Ref: APPLICATION FOR CONSENT UNDER SECTION 36 OF THE ELECTRICITY ACT 1989 (AS AMENDED) AND MARINE LICENCES UNDER PART 4 OF THE MARINE (SCOTLAND) ACT 2010 TO CONSTRUCT AND OPERATE INCH CAPE OFFSHORE WINDFARM (REVISED DESIGN), 15KM EAST OF THE ANGUS COASTLINE

The Electricity Works (Environmental Impact Assessment) (Scotland) Regulations 2017
The Marine Works (Environmental Impact Assessment) (Scotland) Regulations 2017
Inch Cape Offshore Windfarm (Revised Design), 15km East of the Angus Coastline

Inch Cape Offshore Windfarm Revised Design – Consultation

Fig 2G.1: Captures at sea of salmon that either returned to or came from the Tweed (excluding the N. E. England net fisheries)

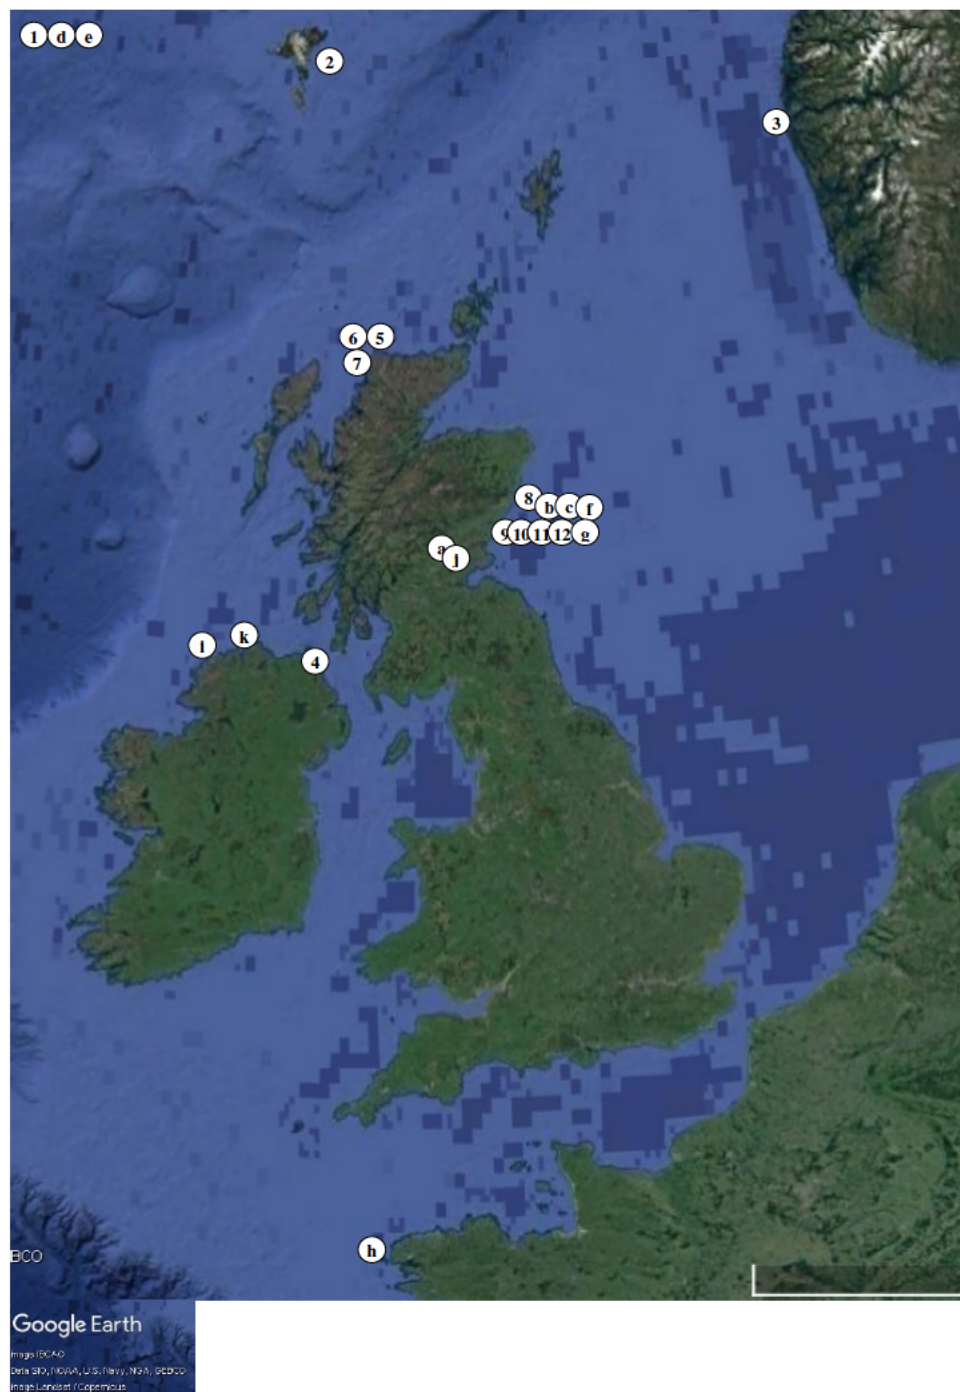
This development will have a more far-reaching effect on rivers further away from the site than the developers have considered. The map below shows the recaptures of Tweed fish at sea, which shows that they have been caught in the Montrose and Aberdeen areas close to the proposed wind farm locations, through which they would have to travel if they then took a straight course to Tweed.

Numbers shown are fish tagged as adults on the coast that later turned up in the R. Tweed; Letters shown are fish tagged as parr or smolts in the Tweed and were later caught at sea

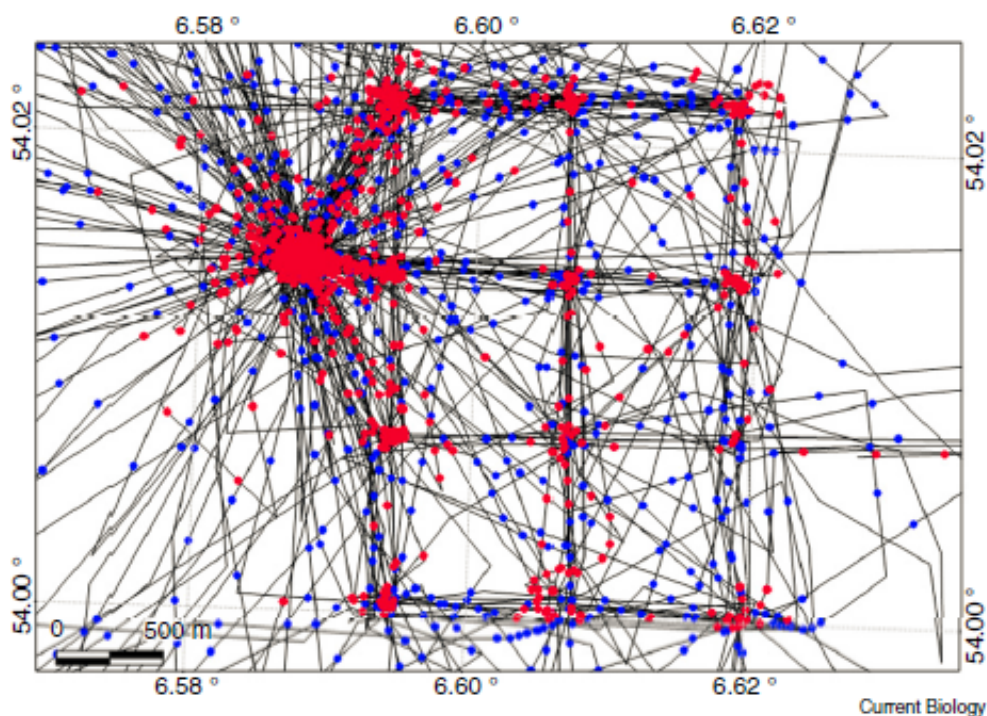
Salmon passing through the area of the proposed development are already vulnerable to predation from the large seal populations on the east coast. New information has shown that the bases of wind turbines act as artificial reefs, attracting both Gray and Harbour seals to hunt around them (*Russell et al, 2014*). Marine wind turbines are therefore now known to alter the foraging pattern of seals and attract them in to areas that they would otherwise have just passed through. The influence of underwater structures on the predation during the offshore migration of Salmon has not therefore been fully considered. The diagram taken from this

paper, below, clearly shows wind turbine to attract seals.

These authors also state: "*The finding that a proportion of seals adjust their behaviour to make use of anthropogenic structures raises questions regarding the attributes of these individuals and the ecological consequences of such behaviour.*" and "*The windfarms considered here were new, and prevalence of such behaviour may increase with time, especially if the artificial reefs are not yet fully established. Even at the levels of prevalence within our sample, this behaviour is likely to be displayed by a large number of individuals given that the population of Harbour Seals in the North Sea is estimated as 55,000 and 65,000 Gray Seals are estimated to haul out on the British coast of the North Sea alone.*"
